Access Compliance Report

Public Rights-of-Way

(Curb Ramps)

Intersection ID: 21737	Main Street: HUNTINGTOWNE_FARMS_LN	Cross Street: PARK_RD	Location: SW
ADA ID: 15593D0BC60A	Ramp Type: PerpDiag	Initial Pass/Fail: Fail	Overall Compliance: No
		Severity Score: 25

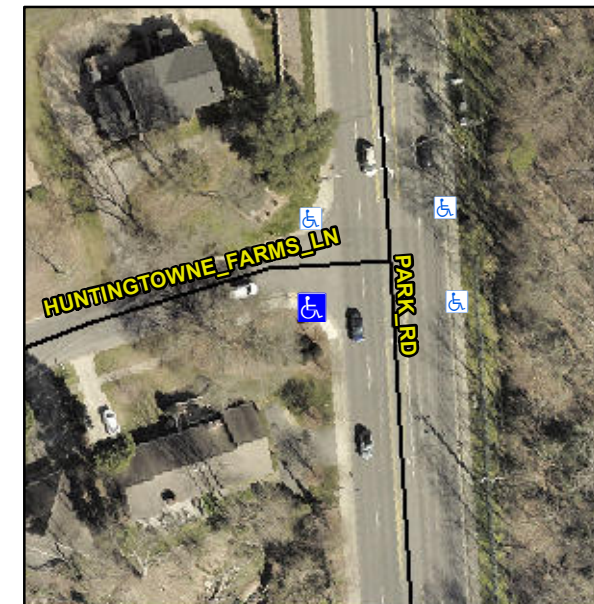
R304.2.2, R304.5.3

Compliance	Description	Data	Compliance	Description	Data
N/A	Ramp Length (in)	61.0	No	Ramp Slope (%)	9.4
Yes	Ramp Width (in)	69.0	No	Ramp XSlope (%)	5.9
N/A	Flare Type LT	N/A	N/A	Flare Type RT	N/A
N/A	Flare Slope LT (%)	N/A	N/A	Flare Slope RT (%)	N/A
N/A	Flare Traversable LT?	N/A	N/A	Flare Traversable RT?	N/A
N/A	Landing Length (in)	N/A	N/A	DWS Provided?	N/A
N/A	Landing Width (in)	N/A	N/A	DWS Contrast?	N/A
N/A	Landing Slope (%)	N/A	N/A	DWS Length (in)	N/A
N/A	Landing X Slope (%)	N/A	N/A	DWS Full Width?	N/A
N/A	Landing Curb? (Y/N)	N/A	N/A	DWS Offset (in)	N/A
N/A	Shared Landing?	N/A			
N/A	Gutter Ponding?	N/A	N/A	Gutter Slope (%)	N/A
N/A	Gutter Lip Ht (in)	N/A	N/A	Gutter X Slope (%)	N/A
N/A	Painted X Walk1?	No	N/A	Painted X Walk2?	No
	X Walk 1 Direction	To E		X Walk 2 Direction	To N
N/A	X Walk 1 Width (in)	N/A	N/A	X Walk 2 Width (in)	N/A
	X Walk 1 Slope (%)	1.5		X Walk 2 Slope (%)	0.7
	X Walk 1 X Slope (%)	0.9		X Walk 2 X Slope (%)	1.2

Remove & Replace Curb Ramp With Two New Directional Ramps or Equivalent.
